High point tower pad and access road

An inspection of the above noted operation was conducted on July 21, 2022 by Manager of Resource Management Herbert Allen.

Permittee:	NWT Energy Corporation (03) Ltd.	Permit Expiry Date:	November 26, 2025
Land Use Permit No.	G18X005	Previous Inspection:	June 30, 2022
Quarrying Permit No.	2021QP0032 - for 300,000cm	Inspection Date:	July 21, 2022
Contractor:		Subcontractor:	
Location(s) Inspected:	High point tower pad and	access road	
Current Stage of Operation:	On-going		
Program Modifications Approved:

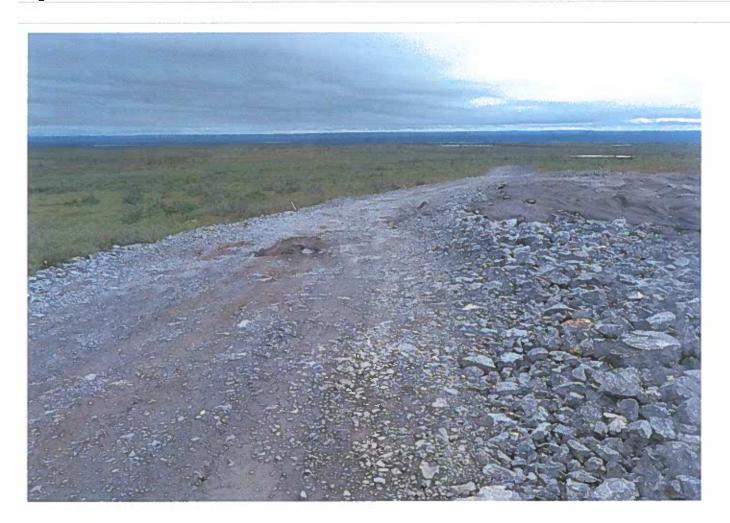
There are a couple of soft spots along the access road that is getting to be a concern and may cause vehicles and heavy equipment to get stuck. The two areas are closer to the top of the access road that should be filled in to prevent a sink hole.
